# DEVELOPMENT CONSENT AUTHORITY DARWIN DIVISION

**AGENDA ITEM: MEETING DATE:** 04/04/2025 **FILE:** PA2024/0287

APPLICATION PURPOSE: RECONSIDERATION Communal space additions (verandah

SUBJECT SITE: Unit 8689, Common Property, Elsey On Parap, (33) Parap

Figure 1: Original proposal vs amended proposal

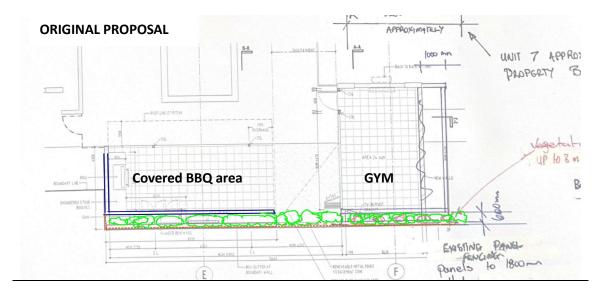
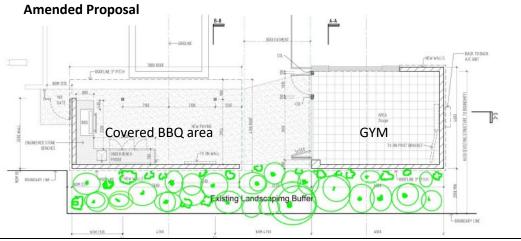
Provide amended plans showing a minimum setback of 2m, with landscaping buffer, between the proposed structures and the southern side boundary.

The revised plans address the points of deferral. The application seeks variation to the 3m side setback requirement under Clause 5.4.3 (Building Setbacks of Residential Buildings and Ancillary Structures). The original proposal and the changes (amended proposal) are illustrated in Fig1, below.

The revised plans seek to address the points of deferral and as a result a setback of 2m with landscaping buffer between the proposed structures and the southern side boundary is provided.

- The existing 2m landscaping buffer along the affected southern side boundary retained, addressing compliance with Clause 5.2.6.1 (Landscaping in Zones other than Zone CB), which requires a planting depth of at least 2m within the side setback in Zone MR.
- Increased southern side setback from 0.6m to 2m.

Figure 9: Proposed and Revised Plan (20/Feb/2025)

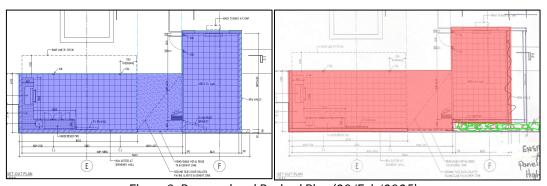
The applicant responded to the submission on 20 February 2025 (**Bookmark C3**), with following amendments:

- The height of the proposed structure adjacent to Unit 7/31 Parap Road has been reduced from 3.8m to 3m to minimize the visual bulk impact.
- The eastern portion of the development has been recessed from the affected boundary, creating a 0.6m setback to Unit 7/31 Parap Road.
- A 0.6m landscaping buffer with potential growth up to 3m in height has been incorporated into the setback area to provide passive cooling and soften the view from Unit 7/31 Parap Road.
- The existing fence along the affected boundary will not be removed. All works will be conducted within the subject site.

Attached at **APPENDIX D** is the markup layout noting the proposed changes to the original layout.

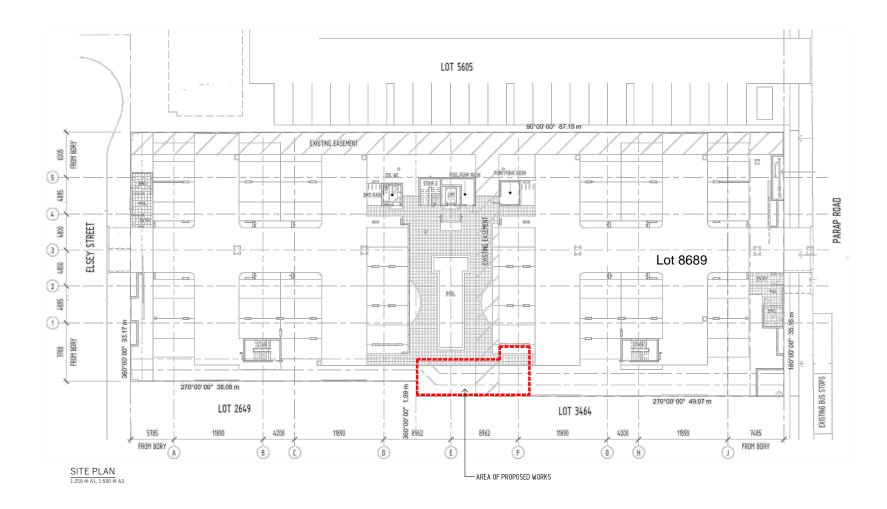
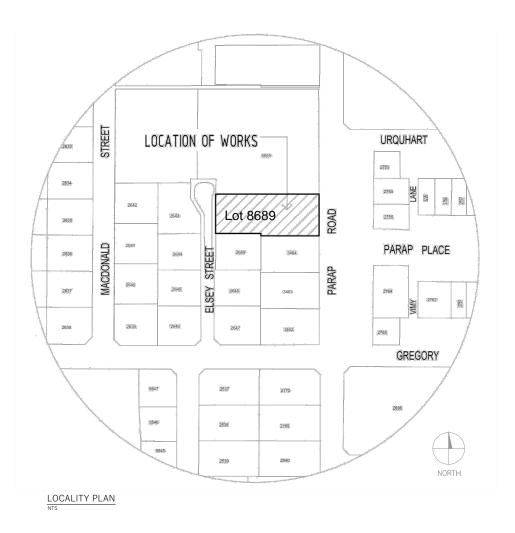
It is confirmed that the proponent will not remove existing fence along the affected side boundary including the fence to Unit 7. All works will be carried out from within the subject development site.
